Re: (FIRST) Plan review comments for: ENG21-00013
23-acre foot water storage reservoir at: 4720 Hardin Rd, St Helena, APN: 018-160-022-000]

Re: Response to FIRST Plan Review Comments for: ENG21-00013
23-Acre Foot Water Storage Reservoir at
4720 Hardin Rd, St Helena, APN: 018-160-022-000

RE: Eakle Reservoir Project, 4720 Hardin Rd, St. Helena (APN 018-160-022-000)
ENG21-00013

EAKLE- HARDIN RD
HYDROLOGY

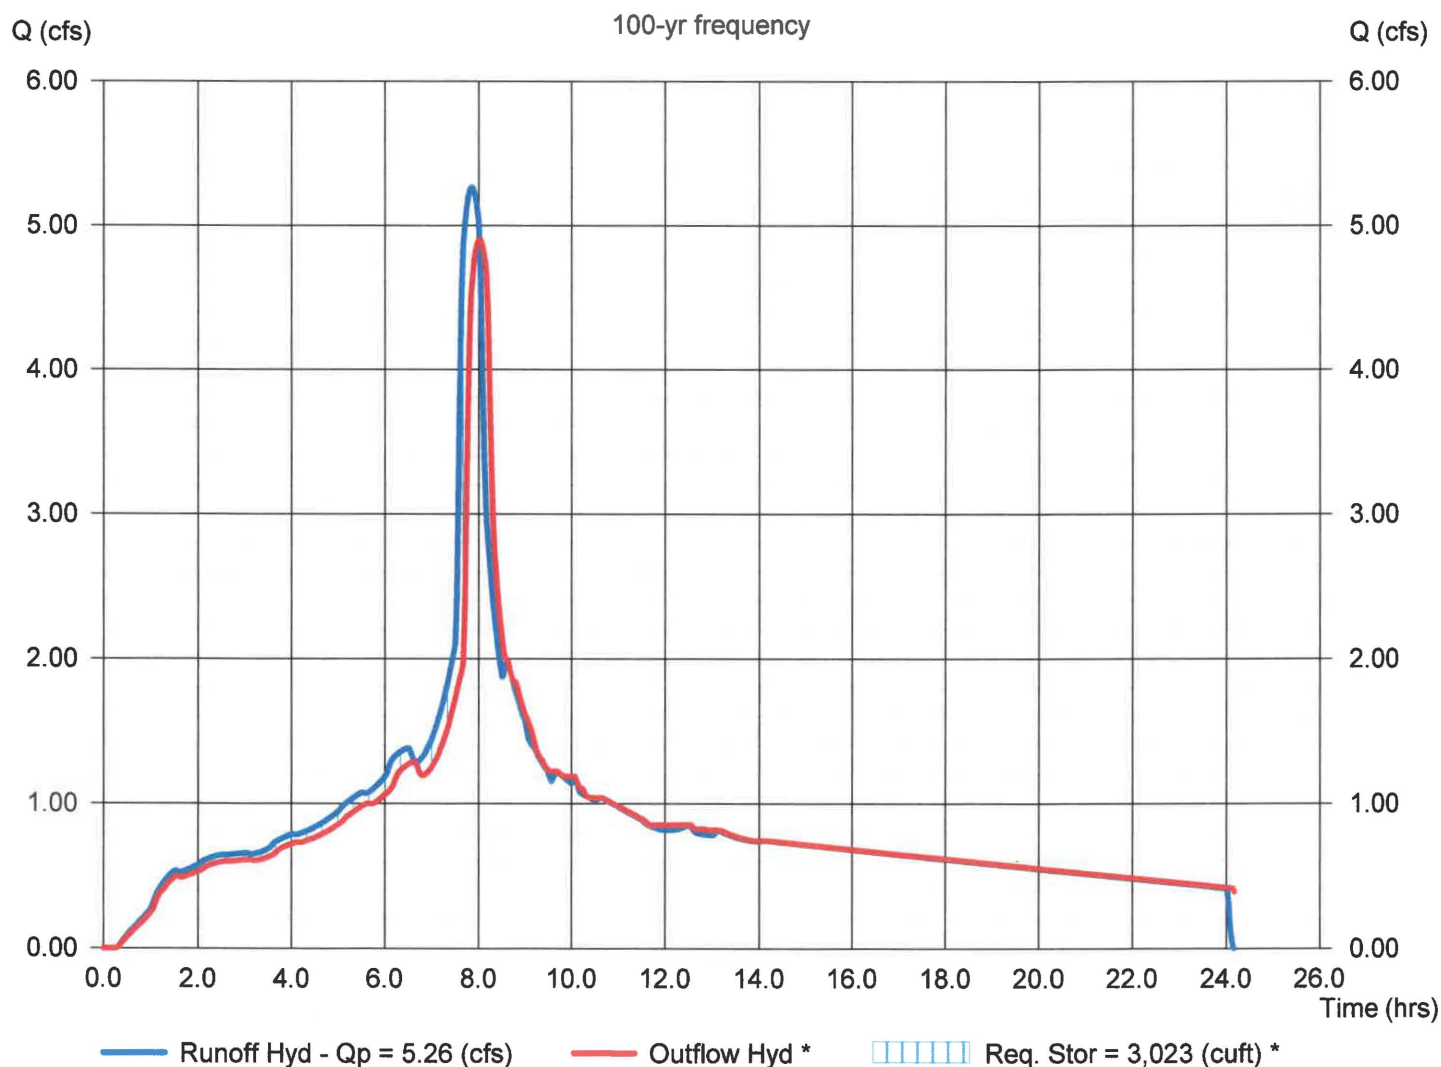
2. Provide information on the water source and demonstrate any infrastructure necessary for diversion, conveyance, etc.
3. Please provide an analysis demonstrating that the overflow structure has the capacity to drain the 10-year storm without additional head and the 100-year storm without overtopping the embankment.

The overflow structure was designed such that it will convey the 100-year storm with one-foot minimum of residual freeboard. A copy of our hydrology and hydraulic analysis for the overflow pipe are attached.

$Q_{100} = 5.26$ cfs - SEE ATTACHED
REPORT

EAKLE-HARDIN RD
OVERFLOW PIPE

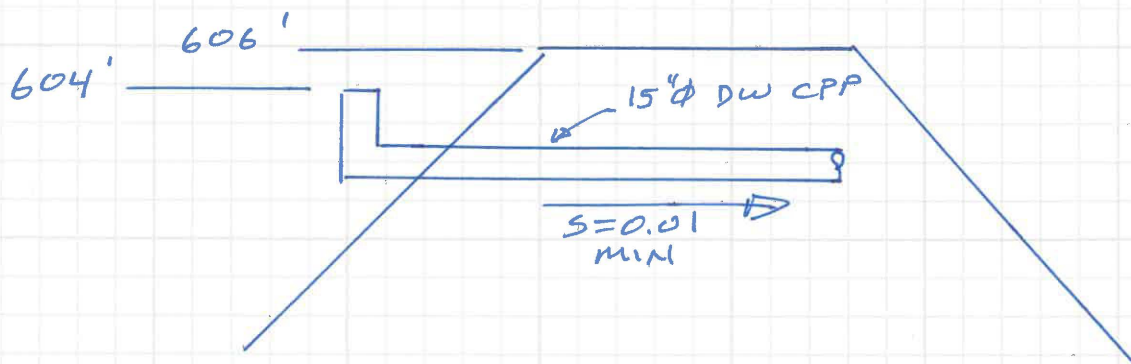
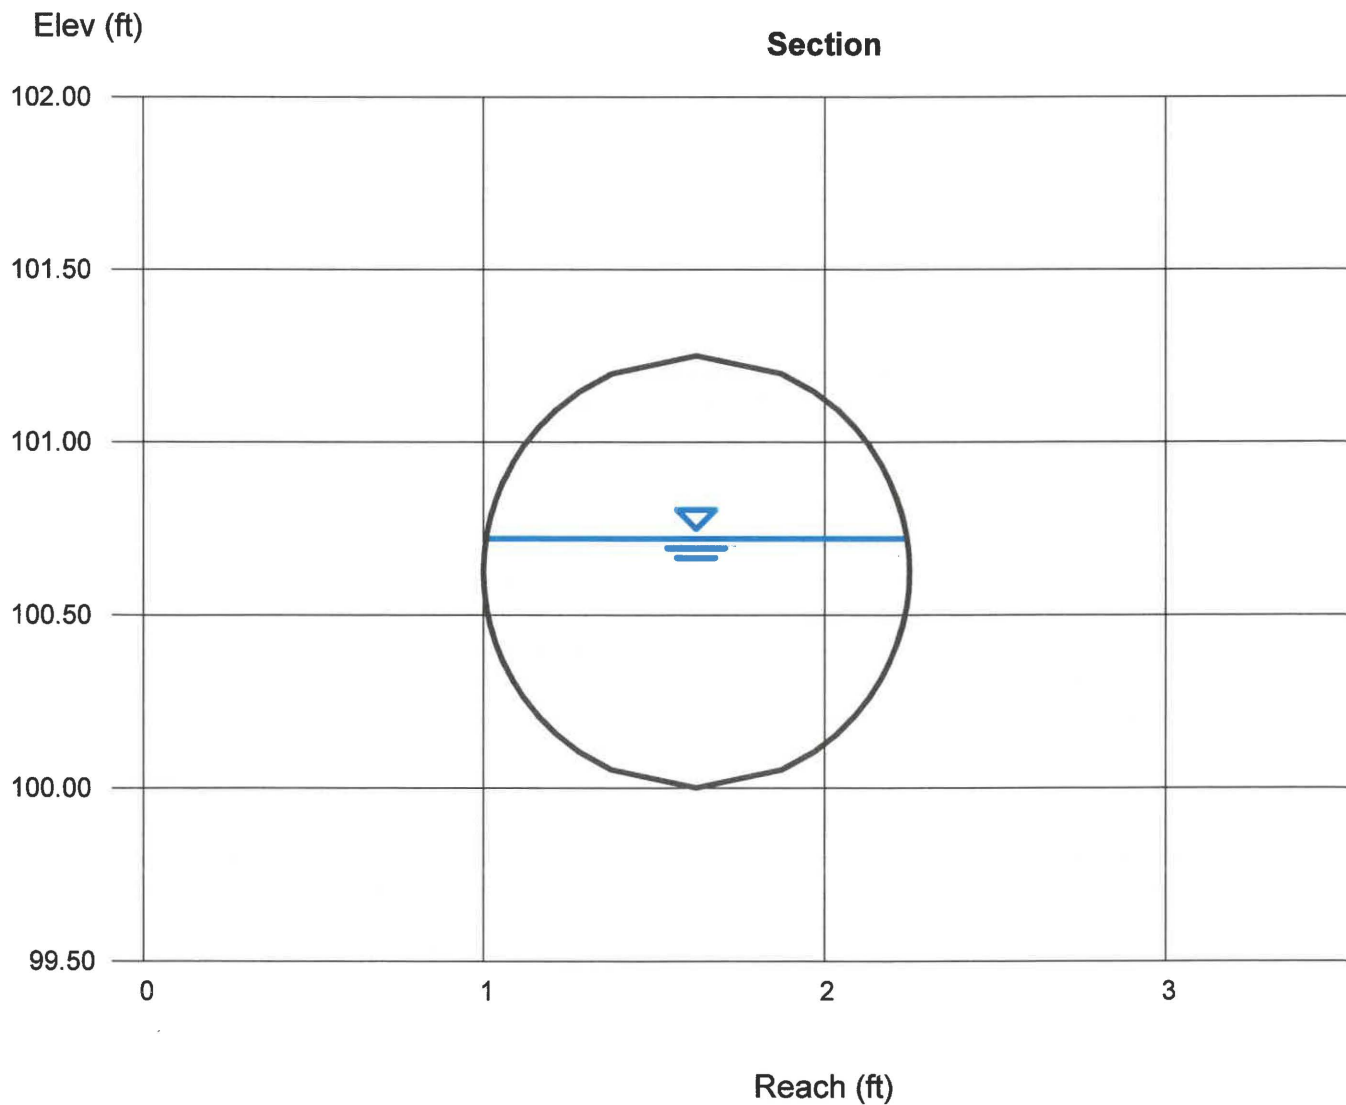
3. *Please provide an analysis demonstrating that the overflow structure has the capacity to drain the 10-year storm without additional head and the 100-year storm without overtopping the embankment.*

PER NRCS NOMOGRAPH, H_{REQ} FOR 5.26 cfs = 0.8'
WHICH LEAVES 1.2-FT RESIDUAL FREEBOARD

AT $S = 0.01$ & $n = 0.012$ (DUAL WALL CPP),
 $d_{100} = 0.72'$ O.K.
